## **X. RESPONSE TO COMMENTS ON 2009 DRAFT EIR**

This chapter of the Final EIR presents copies of all of the comment letters received on the 2009 Draft EIR. A total of 29 comment letters were received on the Draft EIR. The comment letters contained approximately 700 comments. The comment letters have been numbered and given written responses. This volume has been broken down into three sections.

**Type** EIR Draft EIR  
**Description** Request to expand the Landfill footprint; increase permitted tonnage limits; increase Landfill disposal capacity; expand and relocate the Resource Recovery Park, Compost Operation, and the Materials Recovery Facility; change the hours of operation; add staff; and, construct a new entrance.

Figure 1

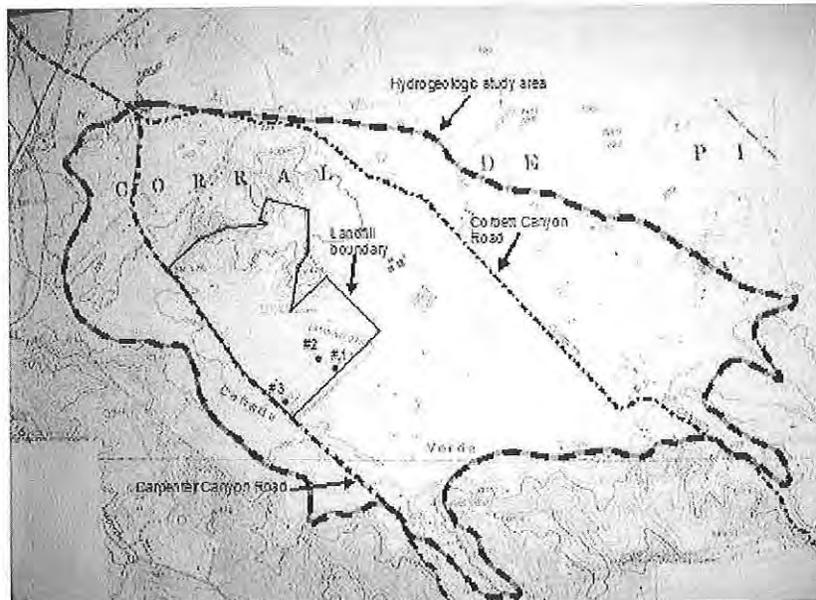
28. Limits of Aquifer. The limits of the aquifer and the characteristics used in the report are in error. The comments below start to address the shortcomings.
29. Lack of Information about Neighboring Wells does not give Accurate Story on Impacts. Figure 1 shows the area around the CCL and the Hydrogeologic Study Area. (Plate 8, Appendix G). How did Fugro determine the basin extent?

Figure 2

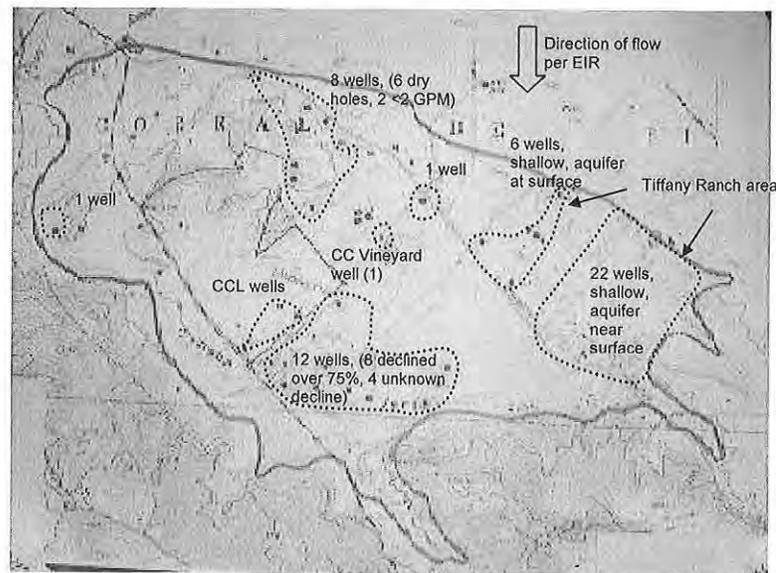
31. **Actual Number of Wells in Area.** The number of wells that Fugro felt were in the area is incorrect; it's drawing *Plate 8*, shows only 11 wells in the Study Area. Three wells Fugro shows are outside of the study area. In reality, there are at least 50 more wells. Figure 2 shows the wells that are missing. To be truly representative of the area, not only the producing wells but also the dry holes that were drilled should be shown. The dry holes (depending on its depth), delineates the aquifer boundaries through the rock record and the water production record. Annotated on the Figure are notes about wells. This data is available through Farm Supply who works on most of the wells. Why these wells are not in the DWR records is unknown, but they were drilled, some in the last 10 years. If it were only a couple of wells, this discrepancy may not be important; when it is 450%, it is material. Again, the Scope of Work required an evaluation of the potential impacts to the neighboring wells. This can't be done without talking to each of the neighbors to get the baseline of the current situation.

33. Dry Farming Indication of Limited Water Aquifer. Again looking at Figure 2, the area between the 12 wells, 22 wells, 6 wells, 1 well and the Corbett Canyon Vineyard well area is an area that is dry farmed, because wells drilled here never produced.

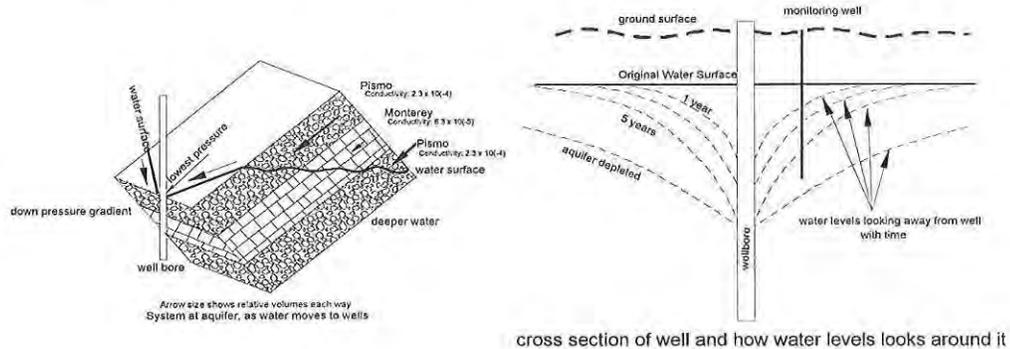
The relative length of the arrows in the drawings shown after the water drops to the interface in the drawing above represent the relative volumes of water that would flow down slope along the interface of the Pismo/Monterey formation or into and thru the

Monterey. In reality, the arrows (flow) only goes down slope to the water level in the reservoir, then, following the path of least resistance, would flow sideways, to the right or left, down the pressure gradient.

Once the water from rainfall percolation hits the water of the aquifer, it flows down gradient towards the lowest pressure. As shown in the drawing, this is a well. If the well did not exist, the water would continue down slope, out towards the ocean, or sea level.

Figure 3 Monterey Top where seen at surface

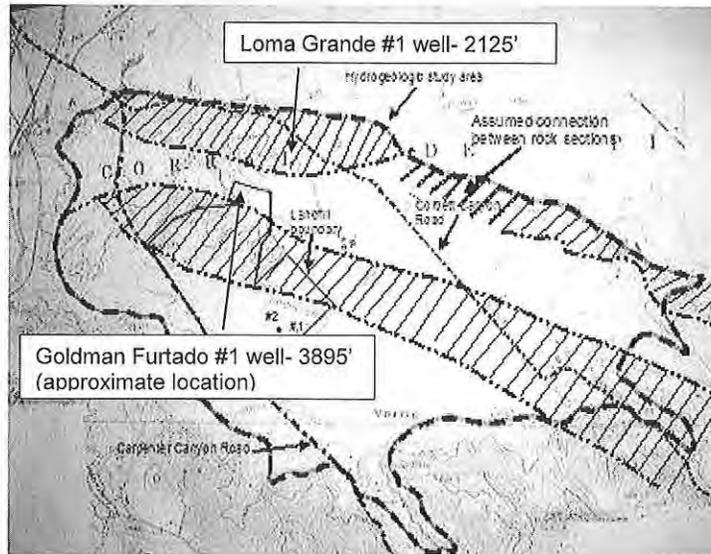
44. Monterey Impact. Due to the relative hydraulic conductivity difference in the Monterey vs. the Pismo sandstone, the Monterey, which goes right down the middle of the hydrogeologic study in 2 parallel beds, acts like a barrier; pressure is transmitted through the zone, but not volume. Figure 3 shows where the Monterey is exposed at the surface. The cross hatched area is the Monterey rock. (Note the exact position shown may be off as I do not have the tools the Morro Group has to display drawings and I am working off copies of copies).

As one looks at the drawing, and visualizes down into the ground, keep in mind that the Monterey formation is very deep. In the Loma Grande #1 well, it was drilled to a TD of 2125' and was all Monterey. In the Goldman Furtado #1 well, located on the landfill property near the top of the landfill, Pismo sands were found between 400-480 feet, and the top of the Monterey was hit around 2000' (1540' SSTVD). From 2000' to TD at 3895', it was solid Monterey.

Figure 4- Cross Section Locations

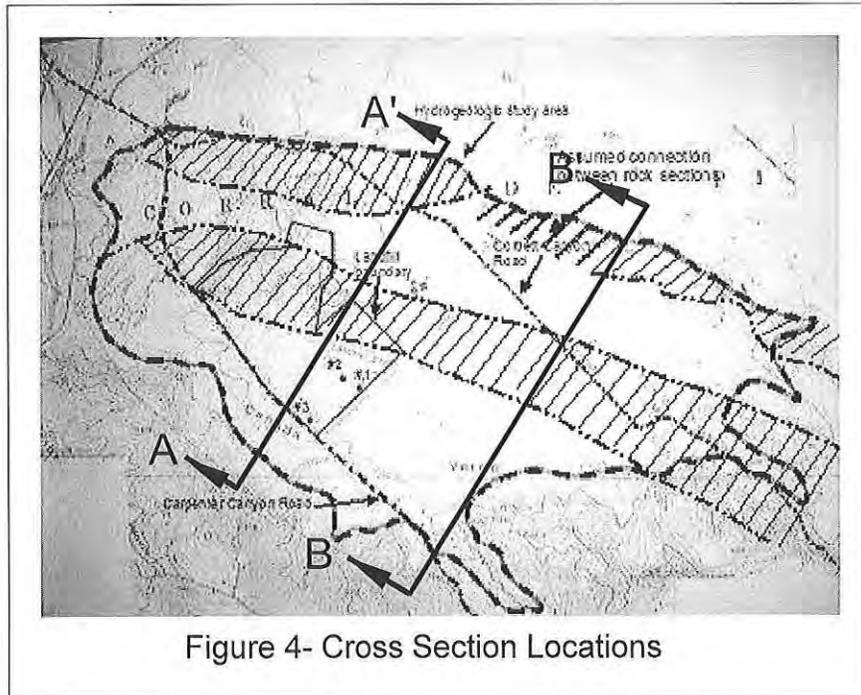
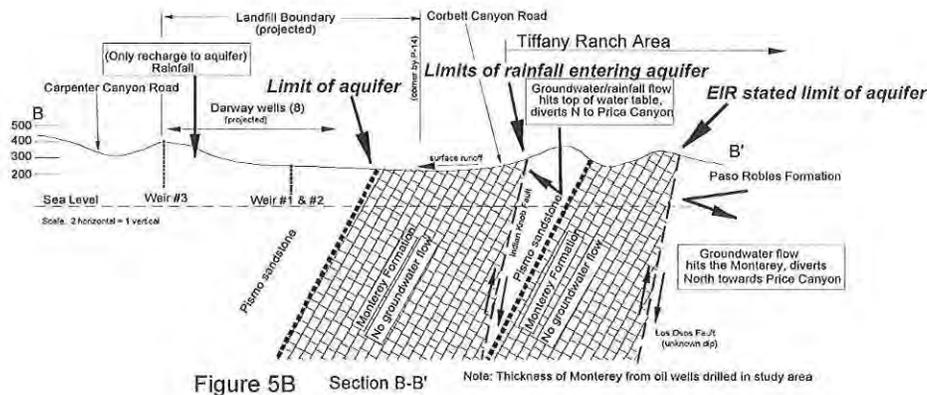
45. Putting Together the Tiffany Ranch Data with the Monterey Data. Putting the production data from the Tiffany Ranch area in conjunction with the cross section of the hydrogeologic study area that is an extension of ERC's 1991 EIR, Figure IV B-3, Diagrammatic Geological Cross Section, but extended to the bounds of the study area along the cross-section lines shown in Figure 4 brings us to the correct hydrogeologic model for the study area and is shown in Figures 5A and 5B. The dips and the Monterey outcrops of around  $41^\circ$  come from the EIR Plate 3. Note that other geologic maps of the area (Diblee) have the dip on the east end of the landfill closer to  $60^\circ$ , the exact degree dip number is not important, but the effect of this steep dip is.

In addition, the area between the two Monterey sections shown in Figure 4, Section A-A' has questionable aquifer characteristics. Two wells drilled on APN 044-171-008 to sea level did not encounter any sandstone that is a water storage reservoir rock below the top of the groundwater water table shown on Plate 6 of the EIR, but generally verified the 280' and 300' contour lines. The key thing is that the rock material was shown to not hold any volume of water. It was described as green silt and soft green shale. The geologic description of Pismo "Sandstone" may be in error, but this doesn't change the overall area model.

Figure 6

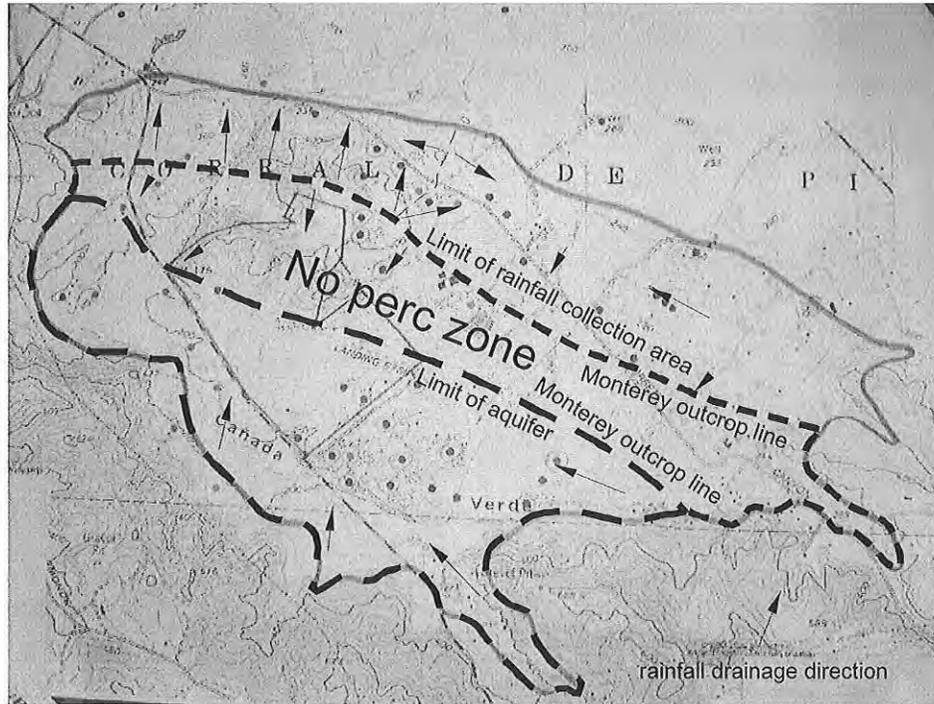
48. Correct Aquifer Limits. Figure 6 shows what I believe the correct aquifer limits should be, based on topographic elevation and direction of rainfall runoff, location of the Monterey blocking formation, and the limits to the west as stated by the EIR. The one streak of alluvial clay/sand running across the study area from the Tiffany Ranch area towards

Corbett Canyon Vineyards is most likely the cutting down into the Monterey and alluvium deposits from the intermittent stream running from the NE to the SW. This stream may directionally help recharge the aquifer, but that volume would be insignificant. I did not show it on Figure 6 because it makes the map more confusing.

EIR Aquifer area: 1687 acres  
 Correct aquifer area: 626 acres  
 Correct rainfall area: 1101 acres

Figure 7

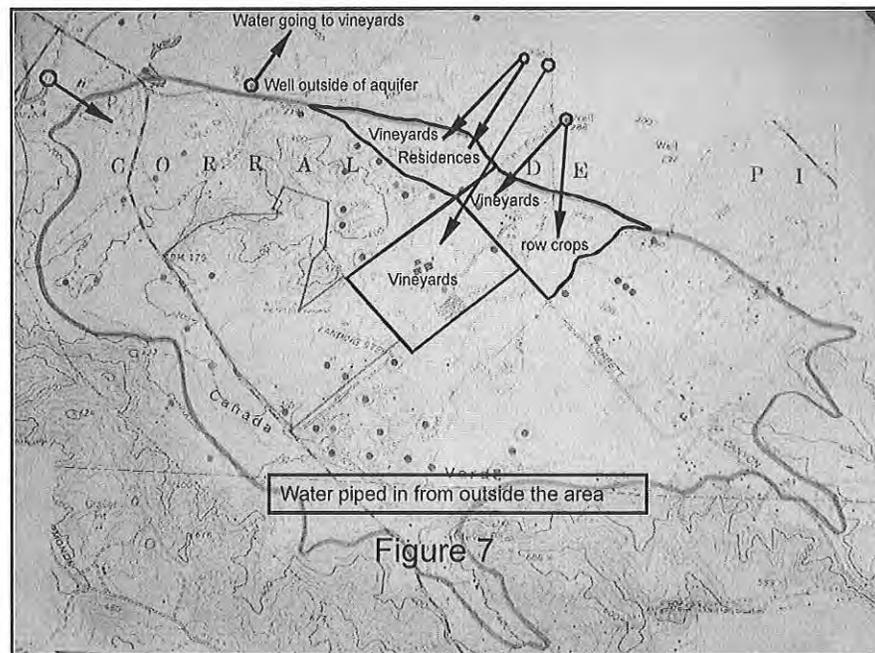
49. Use of Land vs. Land Use Incorrect. It is almost as if the consultants working on this report did not even go to the area and look at the surrounding area. First, the report is correct that the area is zoned Agriculture. However, a great leap of faith occurs, when it states that because it is agriculture, it could be developed into vineyards. This is wrong. To have vineyards, one needs water. Without water, AG land cannot be vineyards. The only way for an AG zoned property to develop a vineyard in the area would be if it imported water from outside of the hydrogeologic study area. That is where the existing vineyards in the EIR's hydrogeologic study area get their water. If the consultants had done the field

surveys that the EIR Scope of Work required, they would have found out that: 1) Corbett Canyon Vineyards (APN 044-261-035), 99.7 acres, gets its vineyard water from outside of the study area. It has one 75 GPM well that has declined in volume to 65 GPM, and that well only operates 25% of the time; 2) the vineyards and irrigated row crops across Corbett Canyon (APN 044-231-032) gets its water from a well over ½ mile outside of the EIR's designated hydrogeologic study area; 3) the vineyard on APN 044-072-052 gets its water from a combination of a well located near the one described under 2) above and the well that is shown outside of the EIR hydrogeologic study area on the north end of Corbett Canyon Road due north of the landfill; 4) the Edna Valley residences surrounded by Parcel APN 044-072-052 get their water from that same well; and 5) APN 044-151-016 gets its water from APN 044-171-017. The well listed as serving the #3 demand by the vineyard and the #4 demands by the residences is outside of the aquifer as evidenced by its production capabilities, 300 GPM and it runs for days at a time. It produces from the alluvium of the Paso Robles Formation. This means the assumption that the build out of the AG area would be vineyards is incorrect. At least, if they are vineyards, they will not be taking water from the CCL aquifer, but from outside the area. Figure 7 shows this inflow of out-of aquifer water.
